INDIANA DEPARTMENT OF TRANSPORTATION

STANDARDS COMMITTEE MEETING

APPROVED MINUTES

RE: Minutes for the May 15, 2008 Standards Committee Meeting

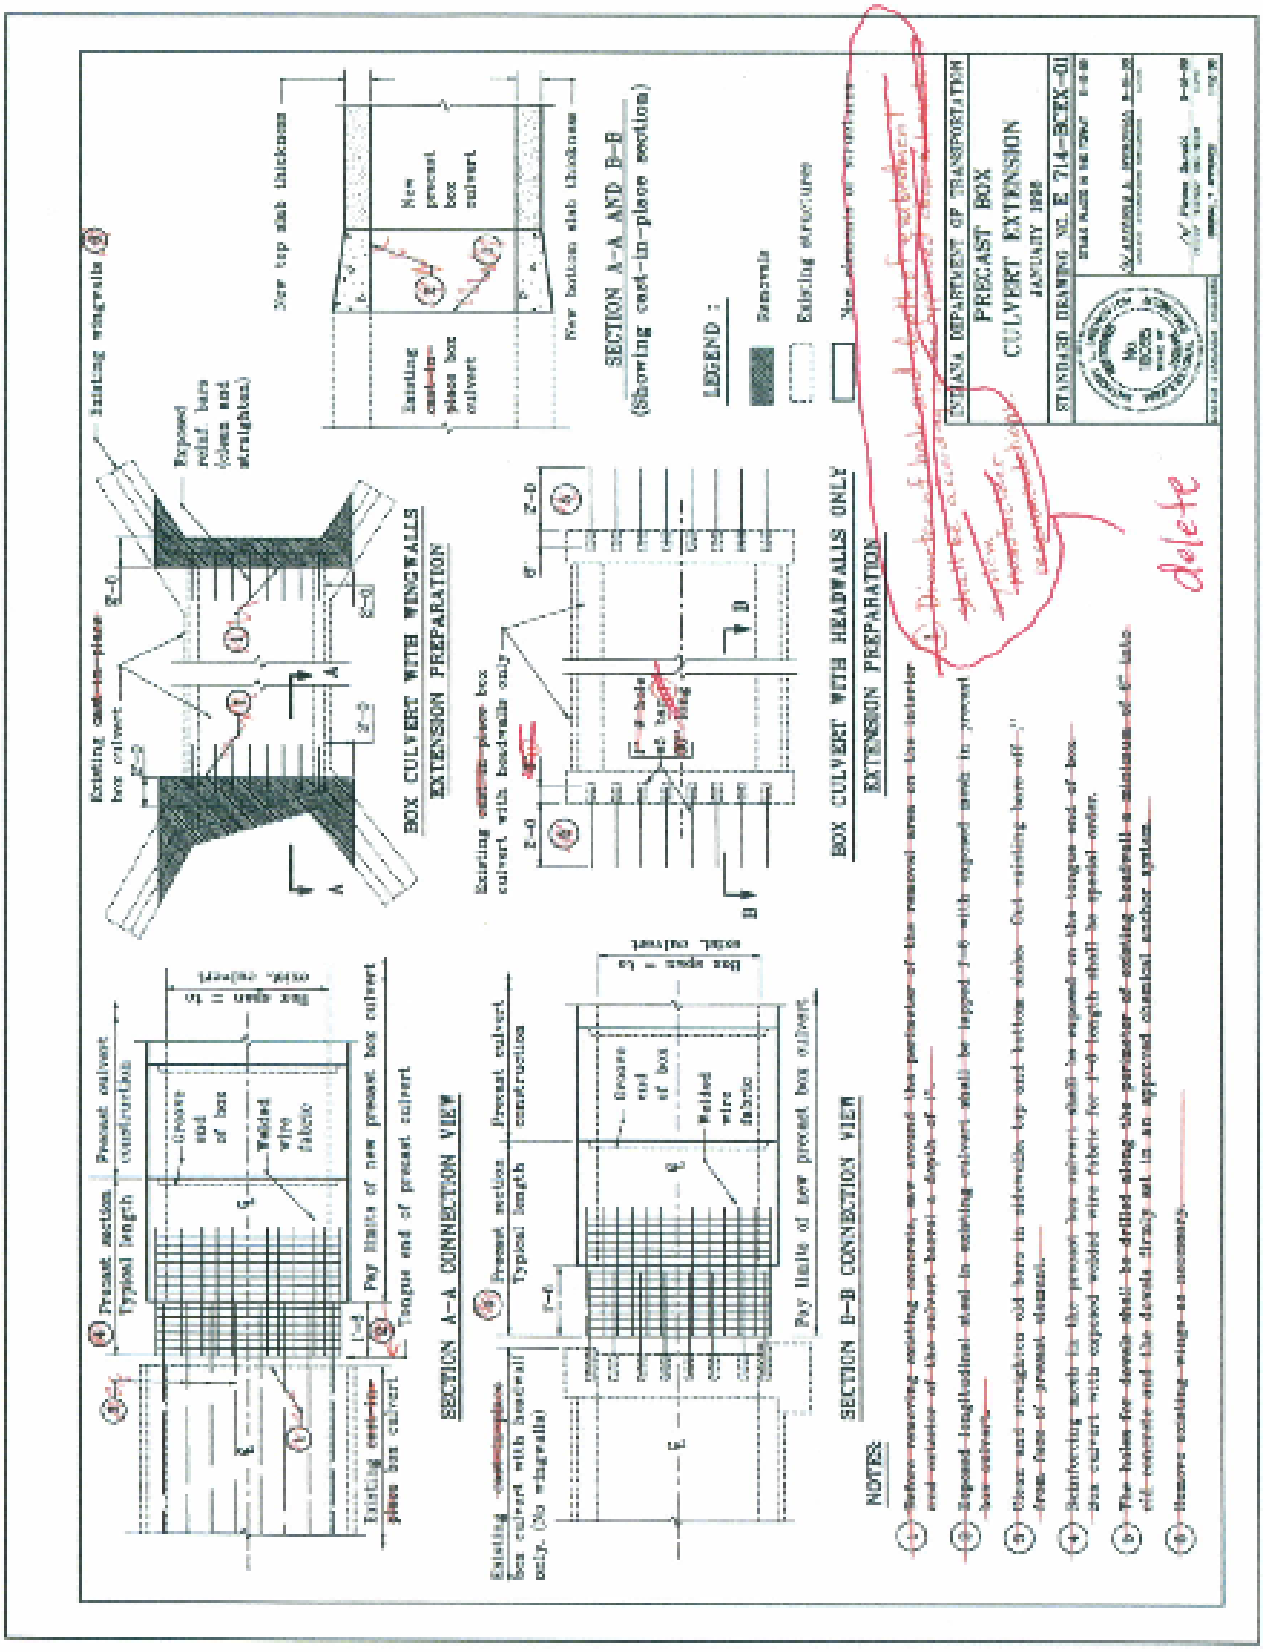
from adjacent new work. Where existing ~~reinforcing~~ reinforcement ~~steel~~ has deteriorated or been damaged during the removal operation, holes shall be drilled into the face of the existing structure to provide embedment for replacement reinforcing bars. The holes shall be of the diameter and ~~length~~ depth required by the manufacturer of the approved chemical anchor system. ~~shown on the plans or as directed and~~ The holes shall be cleaned prior to ~~placement~~ placing ~~of~~ the reinforcement and ~~an~~ the approved chemical anchor system.

No concrete shall be removed from an existing structure that has a headwall but no wingwalls. Reinforcing bars to tie the existing structure to the new culvert section shall be installed by drilling holes into the face of the existing structure to provide embedment for reinforcing bars. The diameter and depth of the holes shall be according to the recommendations of the manufacturer of the approved chemical anchor system. The holes shall be cleaned prior to placing the reinforcement and the chemical anchor system.

A cast-in-place concrete splice shall be constructed as a transition between the existing structure and the precast extension. The splice reinforcement in the new precast extension shall be exposed on the tongue end of the precast box extension and shall be lapped 18 in. (450 mm) with the exposed existing structure ~~reinforcing~~ reinforcement ~~steel and with exposed reinforcing mesh from the extension~~ as shown on the plans. A precast box section with 18 in. (450 mm) of exposed ~~reinforcing~~ reinforcement on the tongue end shall be special order. Existing structure ~~reinforcing~~ reinforcement shall be cut off 1 in. (25 mm) from the face of the new precast extension.

The reinforcing bars for the extension shall be directly lapped with the exposed reinforcement of the existing structure as shown on the plans.
